Variation Notice

Variation Notice No: B/1.2/130/V1
Sheet 1 of 6

1. The Council has decided to vary the permit reference B/1.2/130/RO granted under regulation 10(2) of the Pollution Prevention and Control (England and Wales) Regulations 2000 [SI 1973] in respect of the operation of an installation at Wm Morrison Supermarket Pic Bilston 024 Black Country Route, Bilston, Wolverhampton WV14 0DE

Schedule 1 to Variation Notice Reference: B/1.2/130/V1
Wm Morrison Supermarket Plc Bilston 024 Black Country Route, Bilston, Wolverhampton WV14 0DE

Appendix 2.

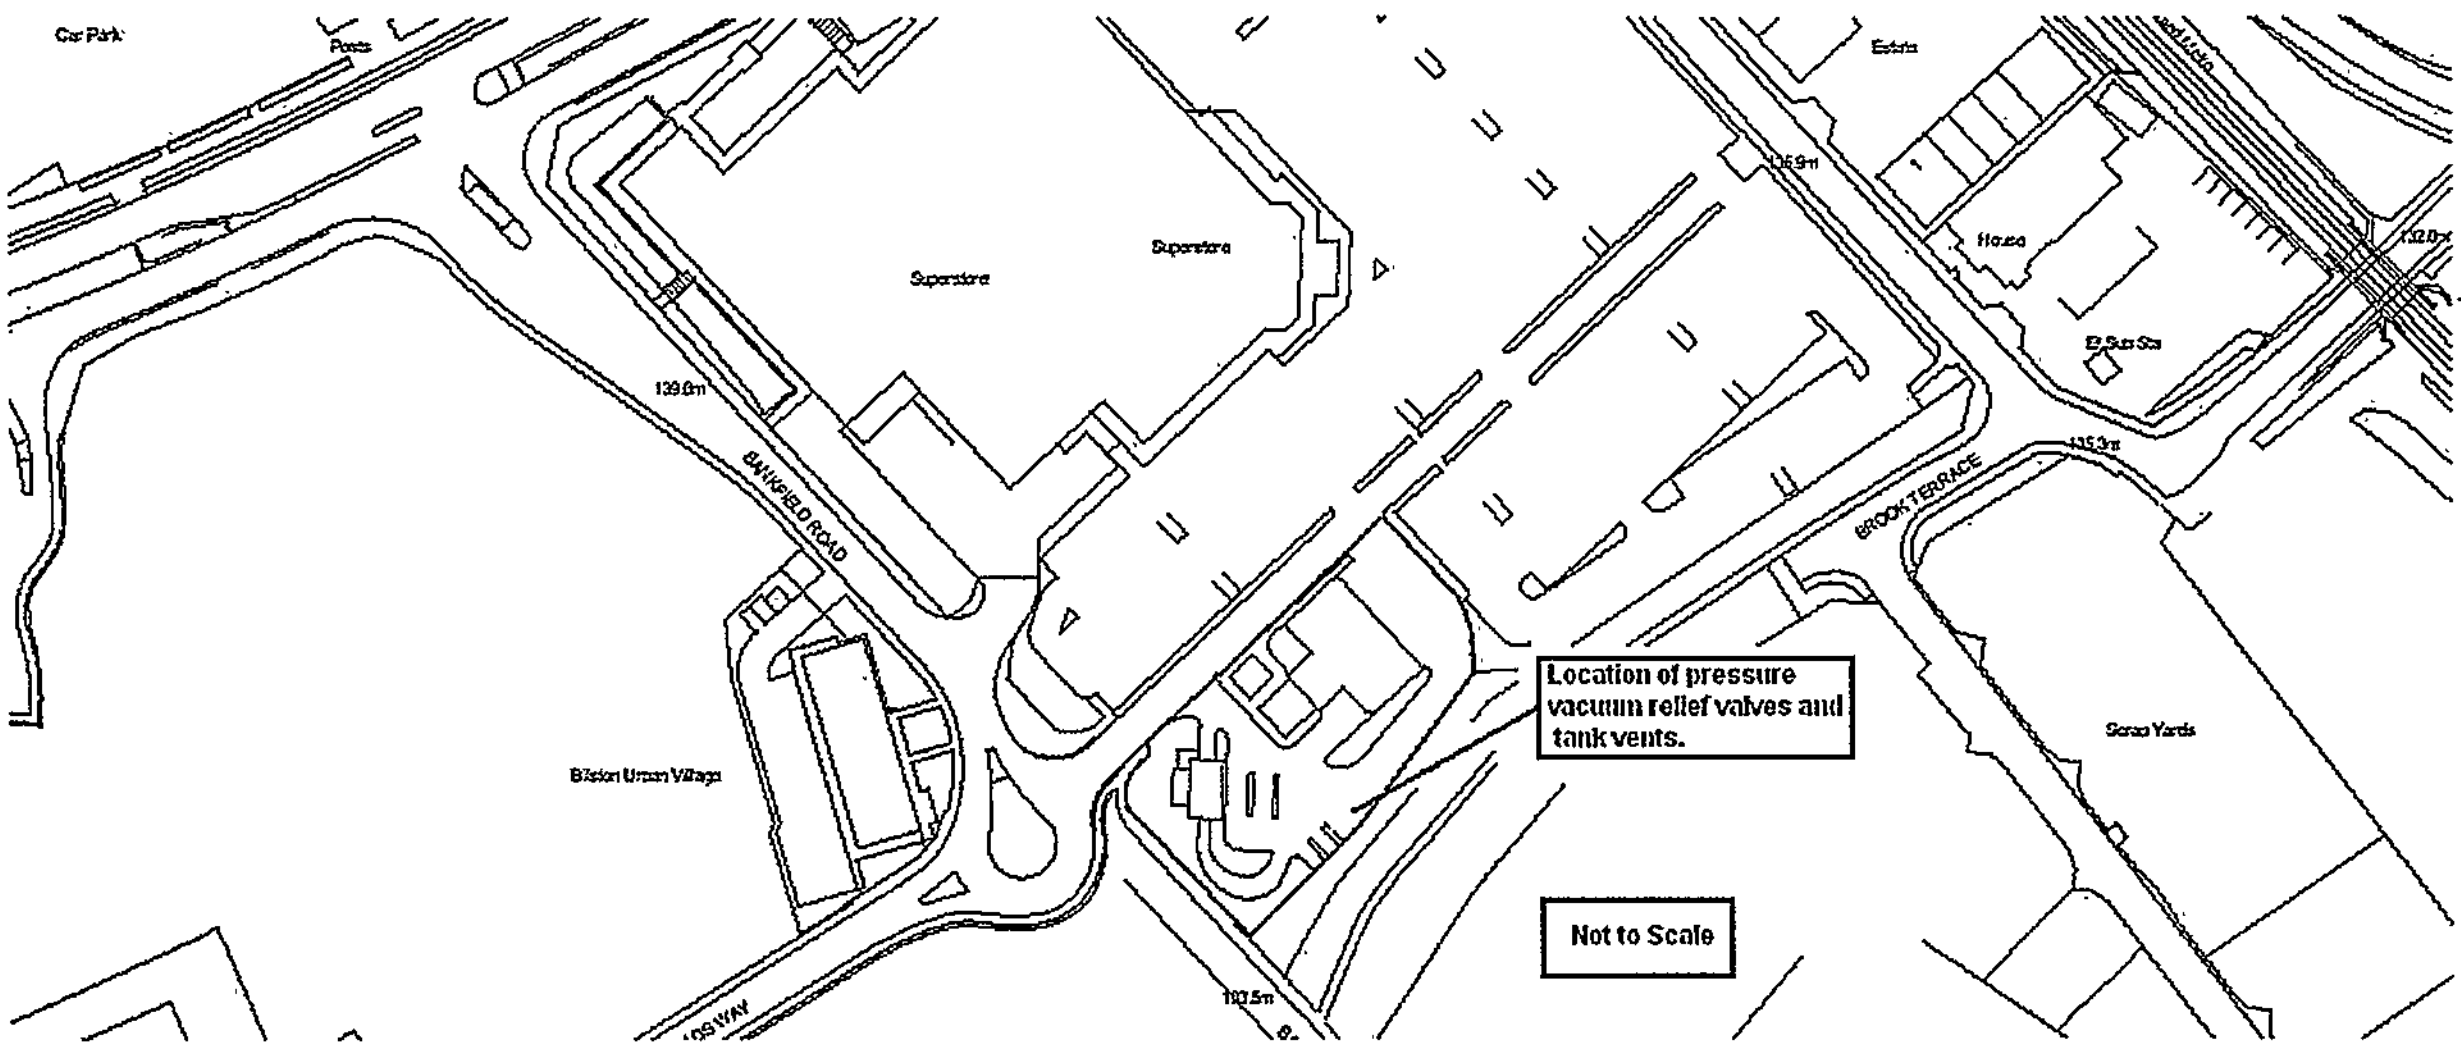
35. Venting of the petrol vapour shall be through the vent pipes marked on the attached plan detailed within appendix 2. Vent pipes should normally discharge not less than 3 metres above the ground, nor within 3 metres of any opening windows or ventilation air inlets.

The following installation location plan is inserted into the permit replacing the previous plan within permit ref: B/1.2/130/RO.
